April 4, 2017

In Reference to ADEQ's Draft Decision to Approve C&H Hog Farm Application Permit 5264-W; AFIN 51-00164,

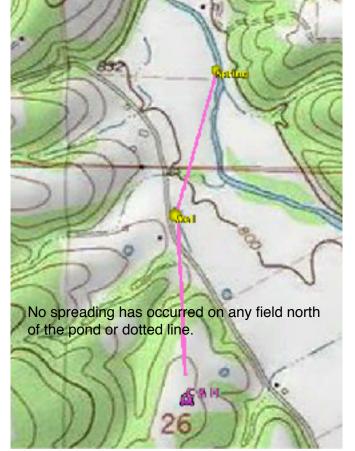
The stream to the right is below C&H Hog Farm. It is below a plugged well that at one time was Mt. Judea's water supply until it was contaminated after dead hogs were thrown into a sink hole upstream. (prior dating to C&H)

Big Creek goes dry and resurges just upstream of this photo. Above this area the closest spreading field is 6270 feet by Big Creek stream.
